HISTORIC AND DESIGN REVIEW COMMISSION

March 17, 2021

HDRC CASE NO: 2021-091
ADDRESS: 362 E HUISACHE AVE
LEGAL DESCRIPTION: NCB 3088 BLK 4 LOT 15
ZONING: MF-33, H
CITY COUNCIL DIST.: 1
DISTRICT: Monte Vista Historic District
APPLICANT: Marc Franco/Trinity Foundation and Construction
OWNER: Josh Wild/Trinity foundation and construction
TYPE OF WORK: Addition and rear deck, porch modifications
APPLICATION RECEIVED: February 12, 2021
60-DAY REVIEW: Not applicable due to City Council Emergency Orders
CASE MANAGER: Huy Pham

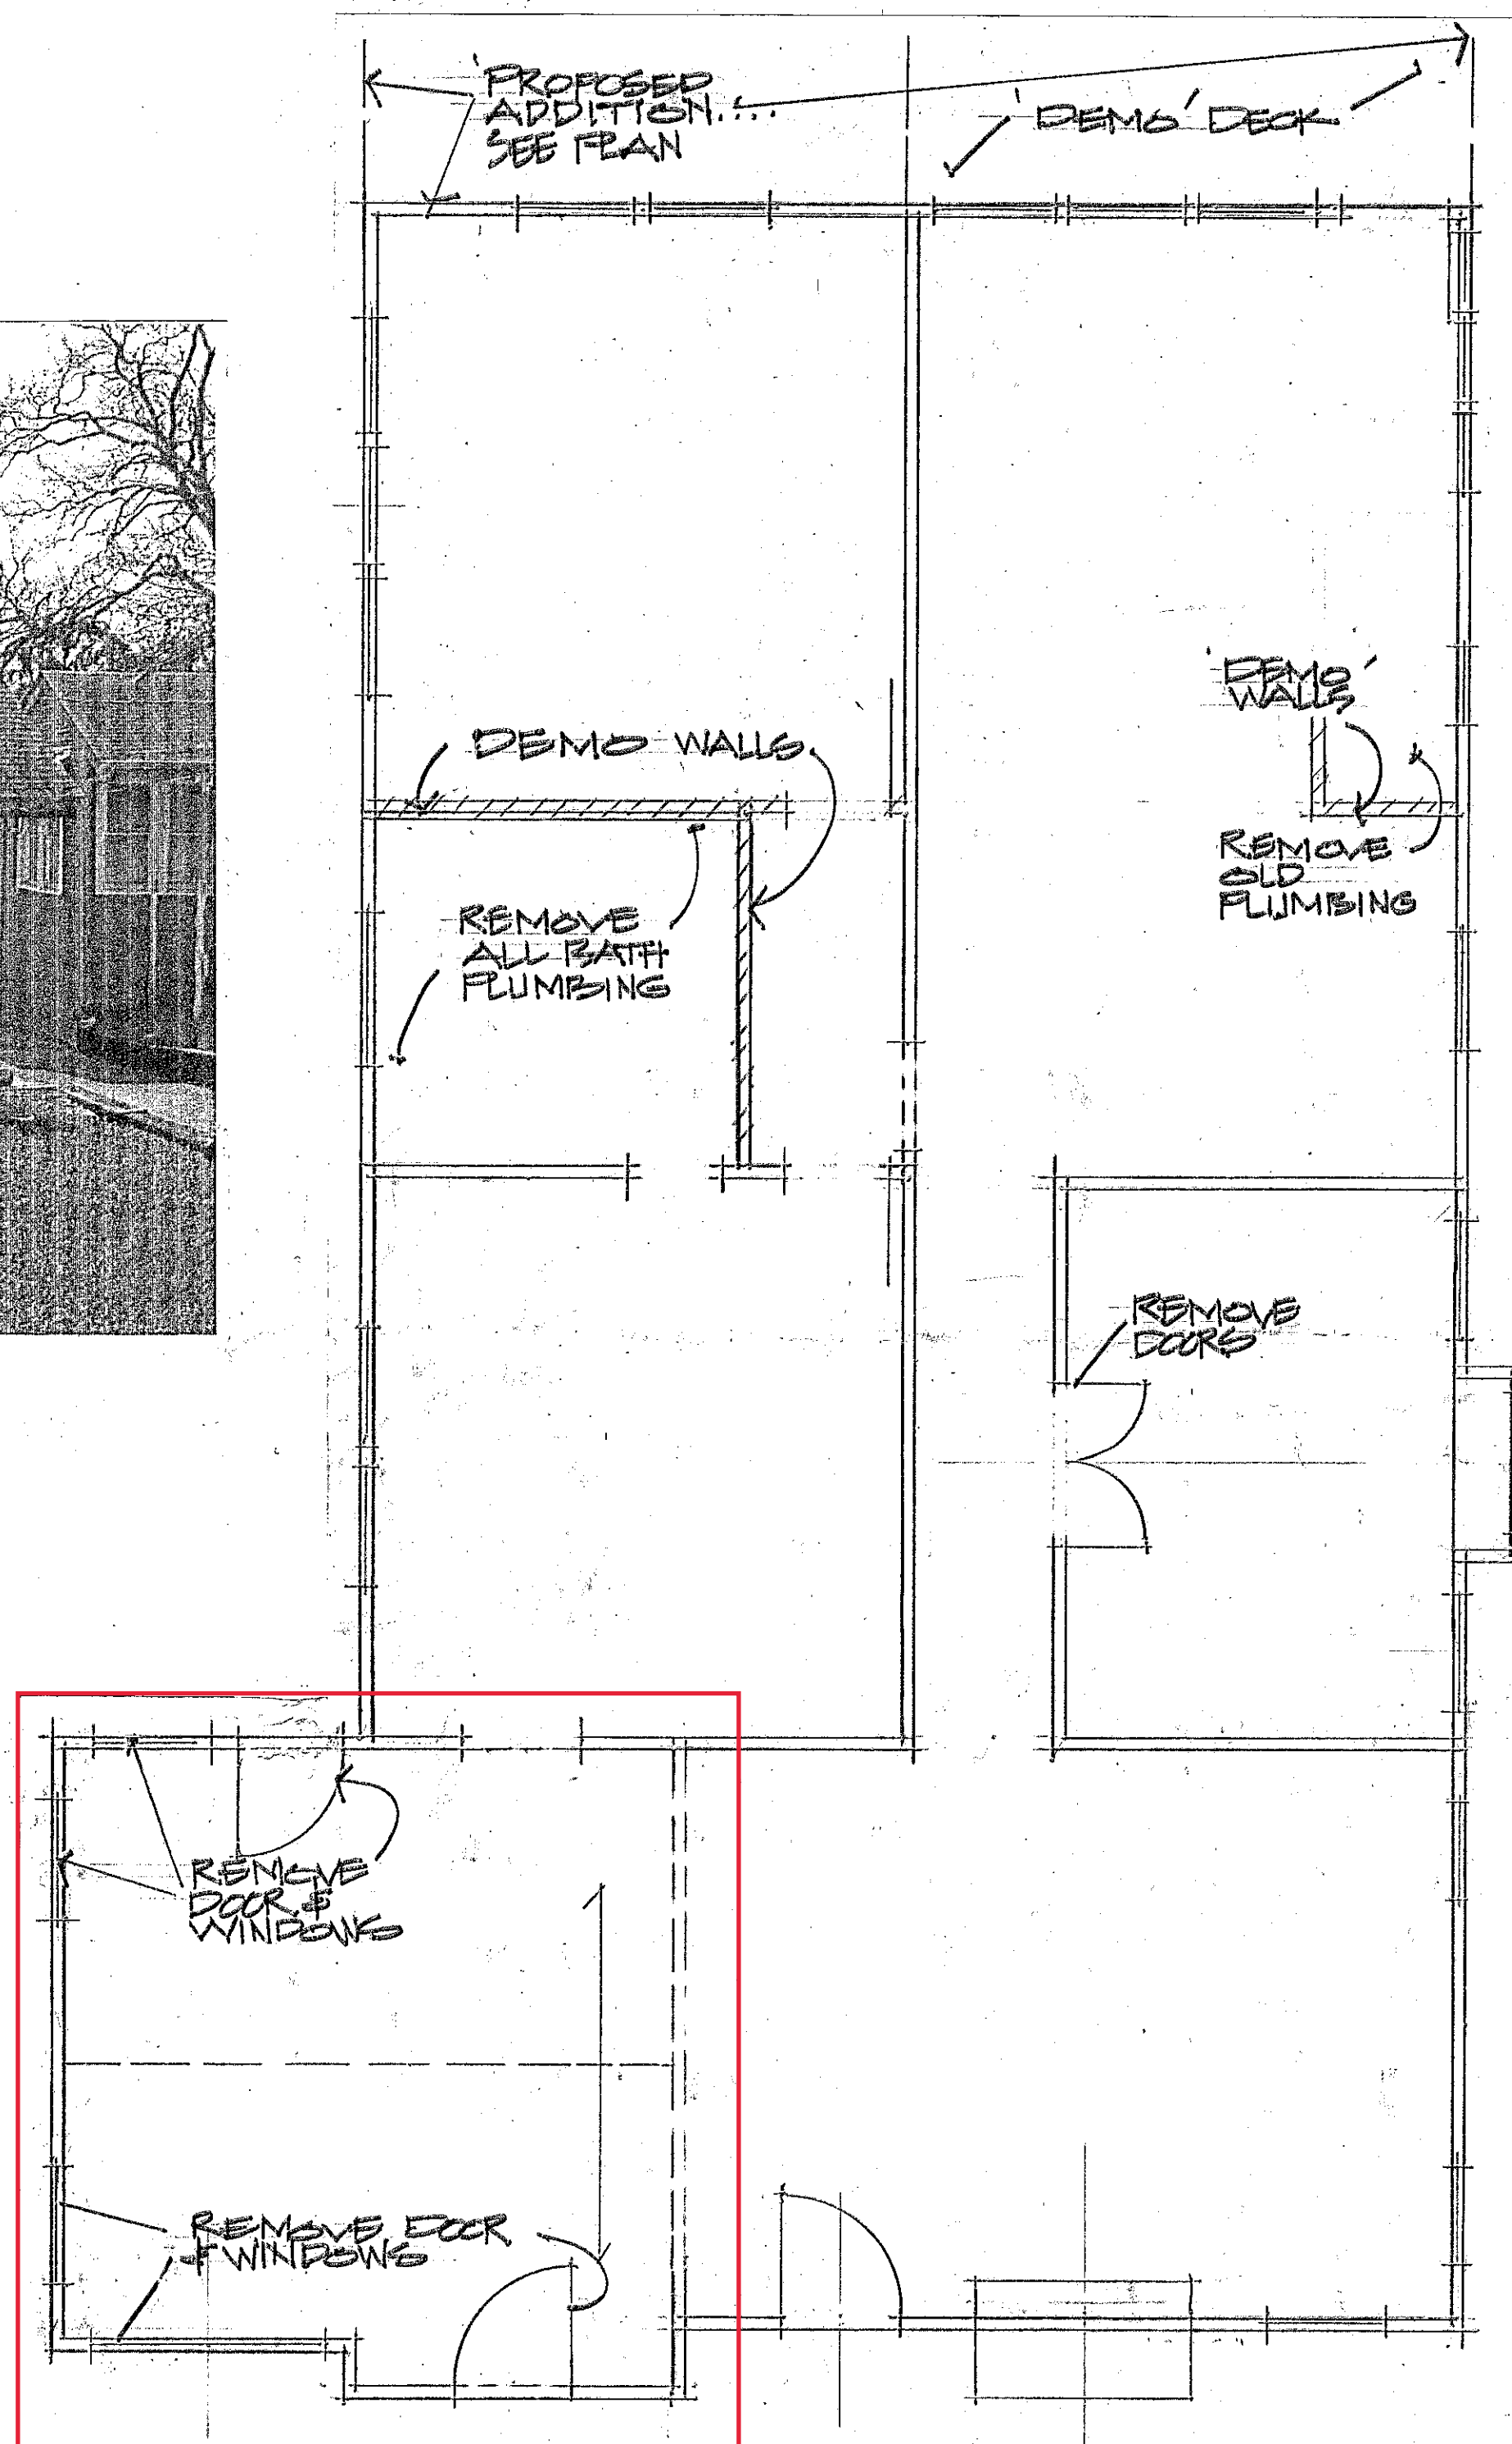
Staff finds the marked area is a front addition per the 1951 Sanborn map

Staff does not recommend approval of item 1. Front porch modification. The front porch should be restored to its previous configuration rather than furthering the nonconforming front porch addition.

LEFT SIDE ELEVATION / SCALE: 1/4" = 1'-0"

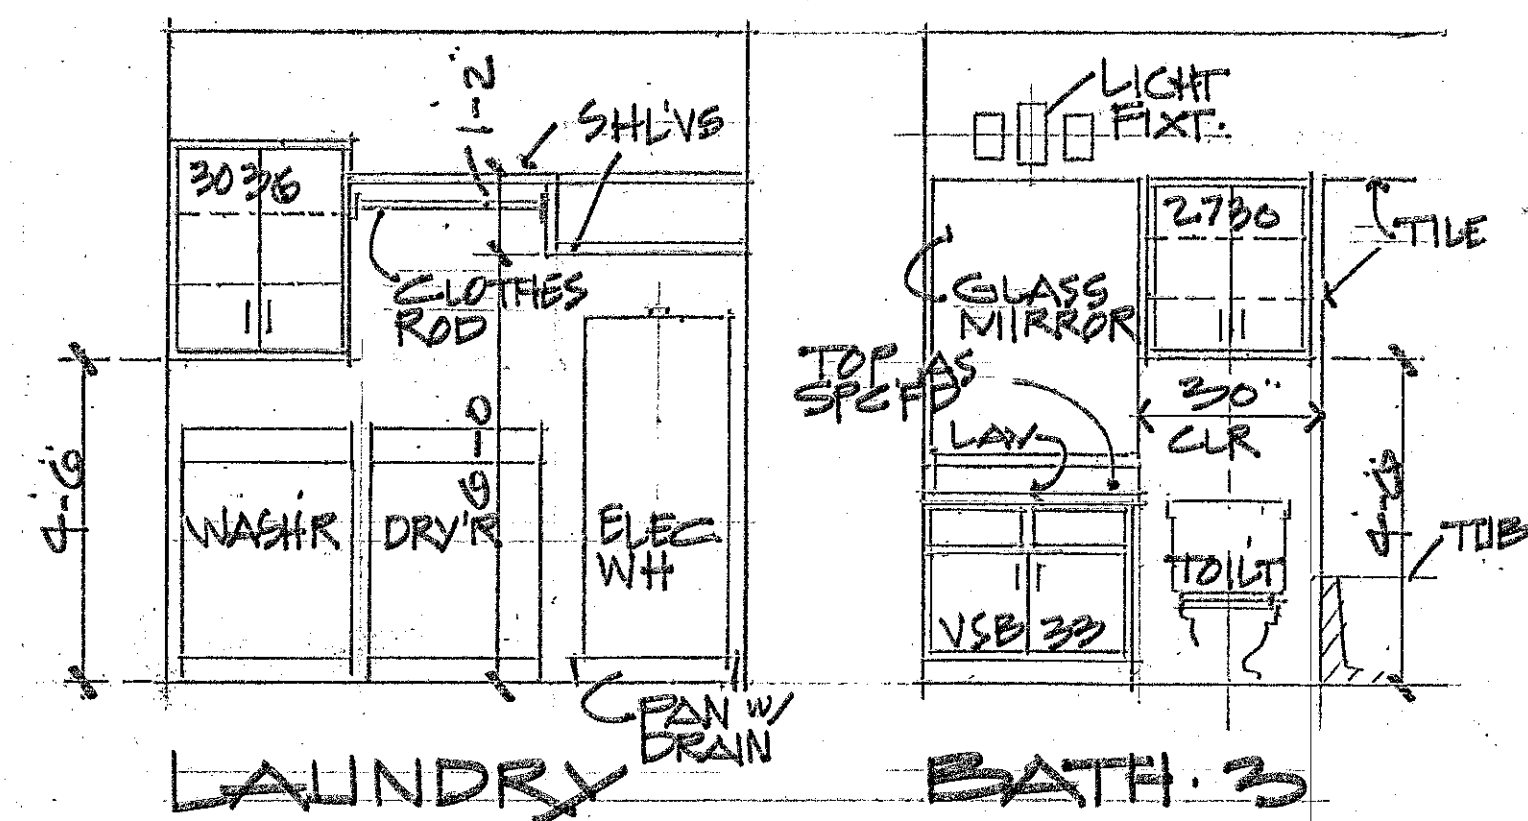
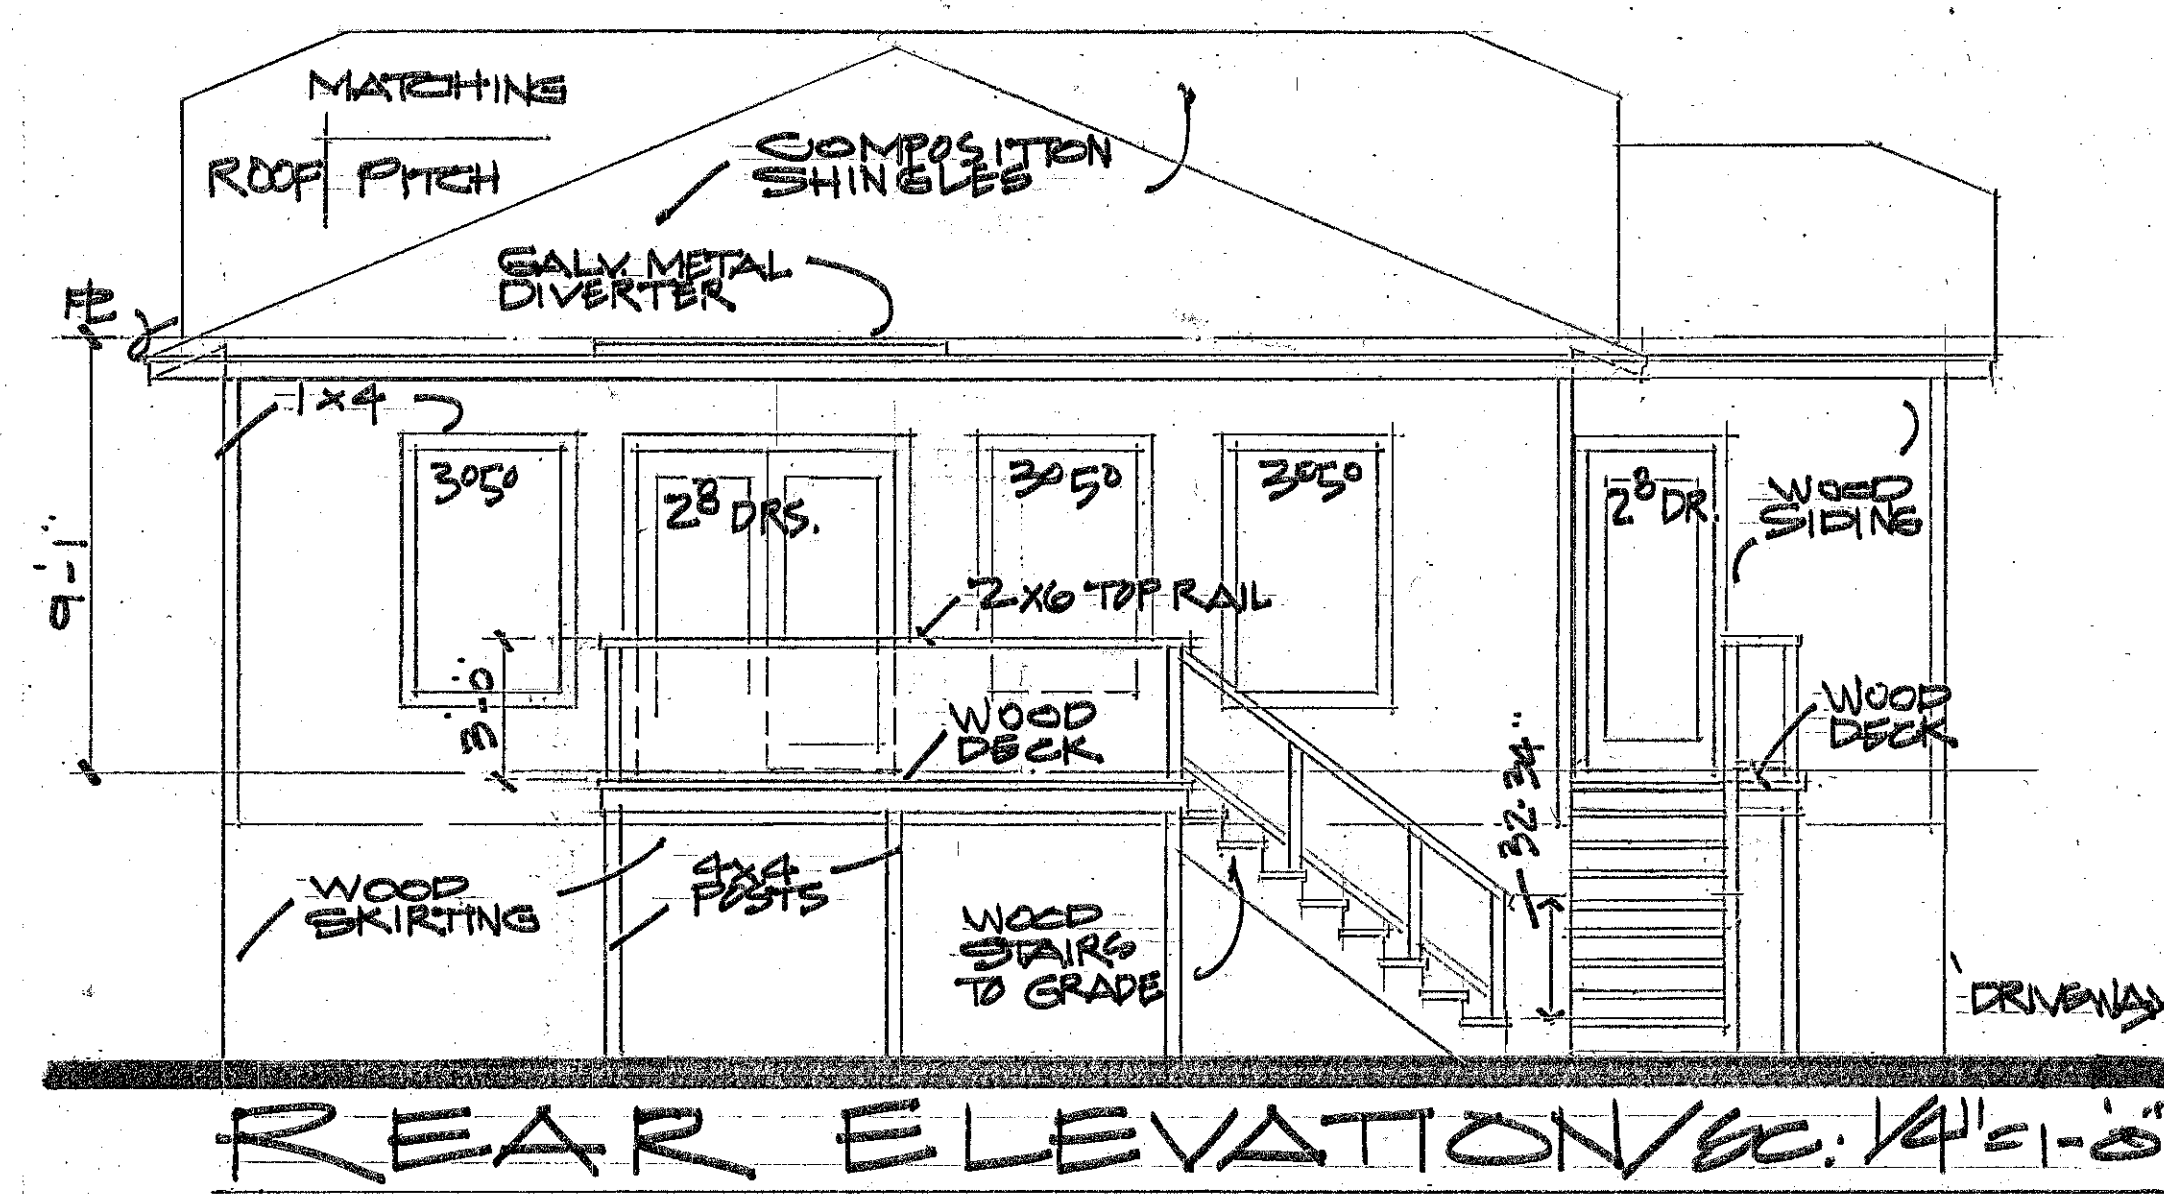
- g. ADDITION TRANSITION – Per the Guidelines for Additions 1.A.iv., applicants should utilize a setback or recessed area and a small change in detailing at the seam of the historic structure and new addition to provide a clear visual distinction between old and new building forms. Staff finds that a vertical trim pieces should be incorporated the side elevations between new and old forms.

Additionally, staff stipulates that the applicant addresses the discrepancies in the submitted elevation drawings prior to the issuance of a Certificate of Appropriateness:

- ii. That a vertical trim piece should be incorporated the side elevations between new and old forms
- iii. That the wood siding profile should match or relate the primary historic structure
- iv. That the new addition windows adheres to the Standard Specifications for Windows in New Construction and Additions. While no material is expressly prohibited by the Historic Design Guidelines, a high-quality wood or aluminum-clad wood window product often meets the Guidelines with the standard stipulation. If the proposed window does not meet the aforementioned stipulations, then the applicant must submit updated window specifications to staff for review, prior to purchase and installation. The proposed vinyl window with faux divided lights does not adhere to the specifications.

- v. That no existing window openings on the side elevations of the primary historic structure are being removed or altered, unless formally requested and approved.
- vi. That no front façade grade changes or front doorsteps are installed, unless formally requested and approved.

FRONT ELEVATION

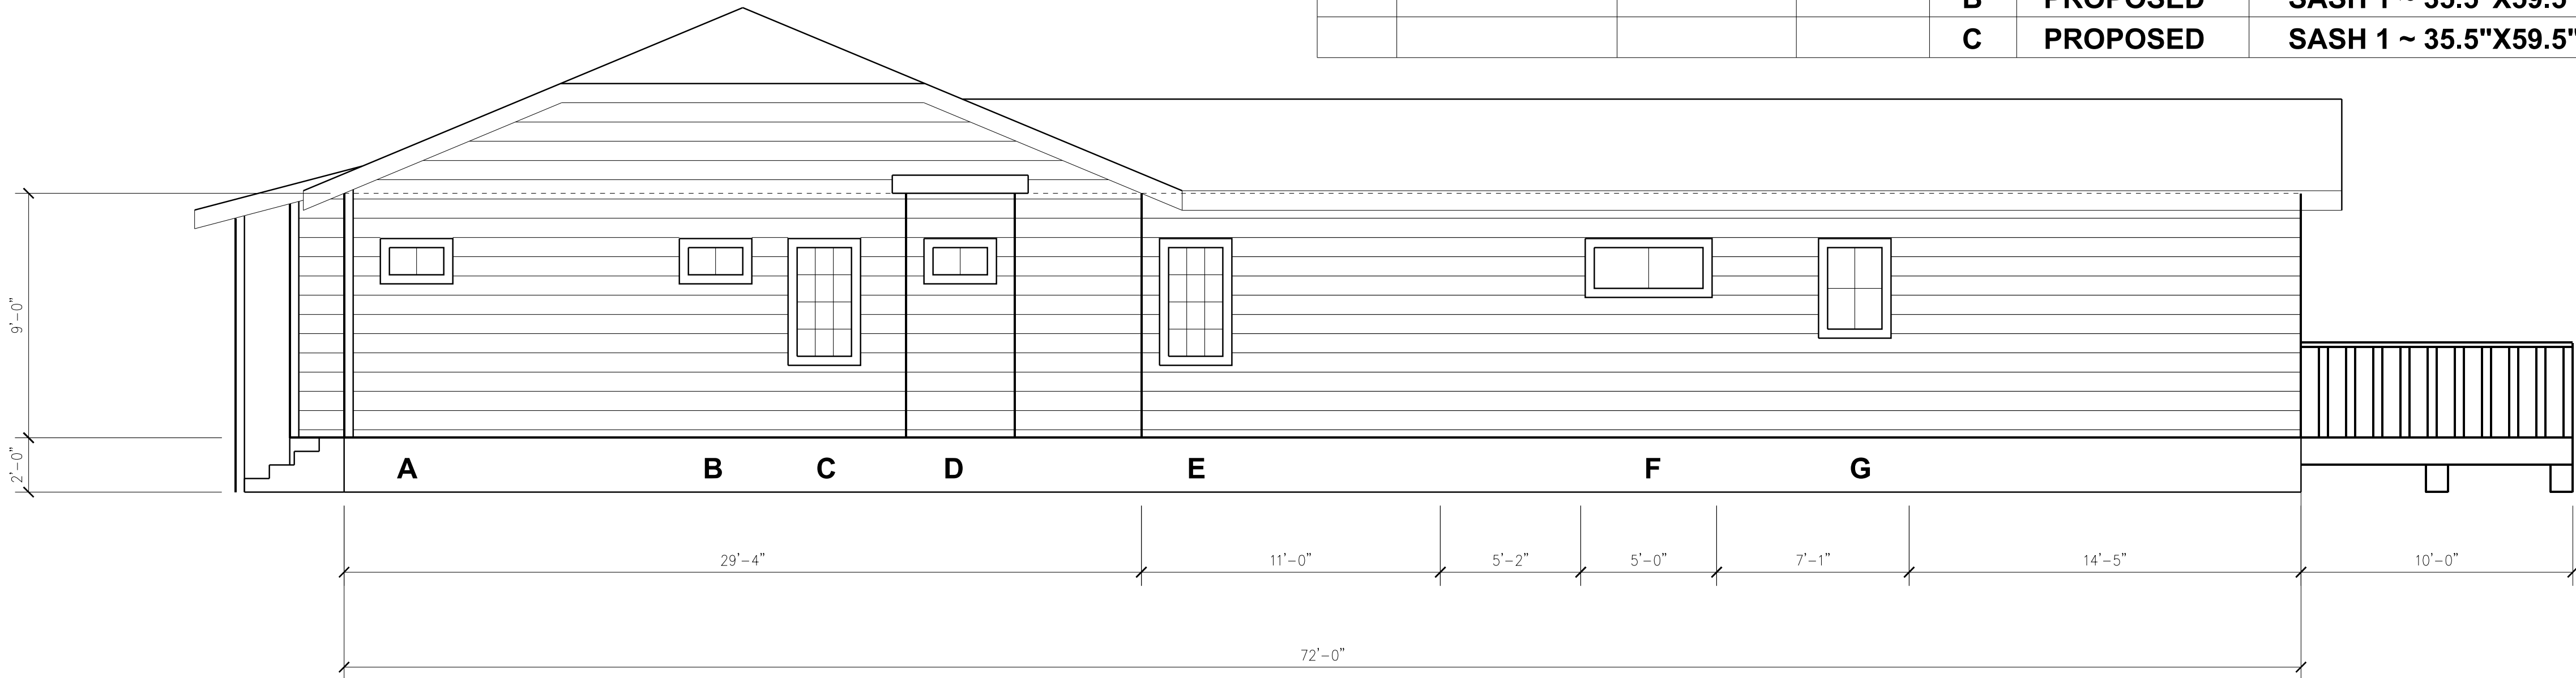
- c. FRONT PORCH – The applicant has proposed to modify the front façade including replacement the front-most door with windows and installing a covered porch. In comparing the existing floorplan with the 1951 Sanborn map, staff finds that the northeast front corner massing, including the front-most window is not original to the structure and was a later front addition the structure. Per the Guidelines for Exterior Maintenance and Alterations 7.B.v. applicant should reconstruct porches, balconies, and porte-cocheres based on accurate evidence of the original, such as photographs. If no such evidence exists, the design should be based on the architectural style of the building and historic patterns. Staff finds that the front porch overhang should be restored to its previous condition based on photographic evidence, rather than introduce furthering the nonconforming front porch addition. Staff finds that replacement of the non-original door with a comparable front window is appropriate if the window adheres to the *Standard Specifications for Window Replacement*. The proposed vinyl window with faux divided lights does not adhere to the specifications.

- i. That the new front window(s) adheres to the Standard Specifications for Windows in New Construction and Additions. While no material is expressly prohibited by the Historic Design Guidelines, a high-quality wood or aluminum-clad wood window product often meets the Guidelines with the standard stipulation. If the proposed window does not meet the aforementioned stipulations, then the applicant must submit updated window specifications to staff for review, prior to purchase and installation. The proposed vinyl window with faux divided lights does not adhere to the specifications.
